Access Compliance Report Public Rights-of-Way (Curb Ramps)

Main Street: FAIRHAVEN_AVE Cross Street: PALOMAR_WAY Location: SE

ADA ID: RPAT211022093616 Ramp Type: Type 6 - Directional 1 Initial Pass/Fail: Fail Overall Compliance: No Severity Score: 2

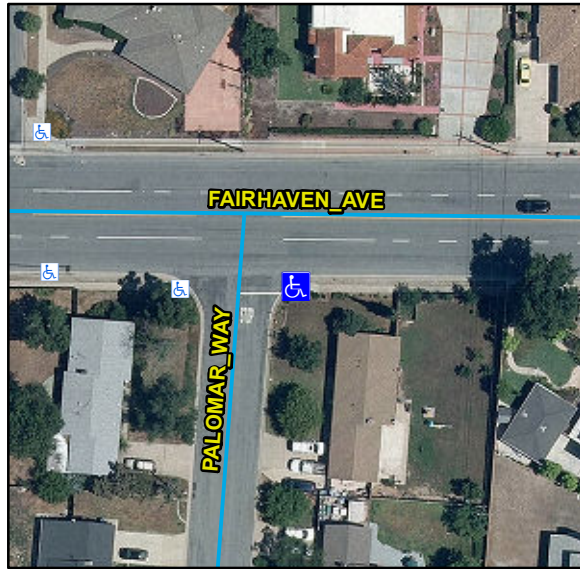
Compliance	Description	Data	Compliance	Description	Data
N/A	Ramp Length (in)	170	N/A	Flare Type LT	
Yes	Ramp Width (in)	60			N/A
Yes	Ramp Run Slope (%)	8.1	N/A	Flare Slope LT (%)	N/A
No	Ramp Cross Slope (%)	2.3	N/A	Flare Traversable LT	N/A
N/A	Grade Break	N/A	N/A	Flare Type RT	
N/A	Grade Break Slope (%)	N/A			N/A
N/A	Grade Break Cross Slope (%)	N/A	N/A	Flare Slope RT (%)	N/A
	Addl Para Ramp Left?	No	N/A	Flare Traversable RT	N/A
	Addl Para Ramp Right?	No	N/A	DWS Provided	N/A
N/A	Landing Present	N/A	N/A	DWS Contrast	N/A
N/A	Landing Length (in)	N/A	N/A	DWS Length (in)	N/A
N/A	Landing Width (in)	N/A	N/A	DWS Full Width	N/A
N/A	Landing Run Slope (%)	N/A		DWS Offset Type	N/A
N/A	Landing Cross Slope (%)	N/A	N/A	DWS Left Offset (in)	N/A
N/A	Landing Movement Obstructed?	N/A	N/A	DWS Right Offset (in)	N/A
	Landing Movement Type	N/A			
N/A	Landing Shared	N/A			
N/A	Marked Crosswalk 1	No	N/A	Clear Space	Yes
	Crossing 1 Direction	N	N/A	Clear Space To Crosswalk (in)	N/A

Remove & Replace Curb Ramp With Two New Directional Ramps or Equivalent.

R304.5.3, STD 1115
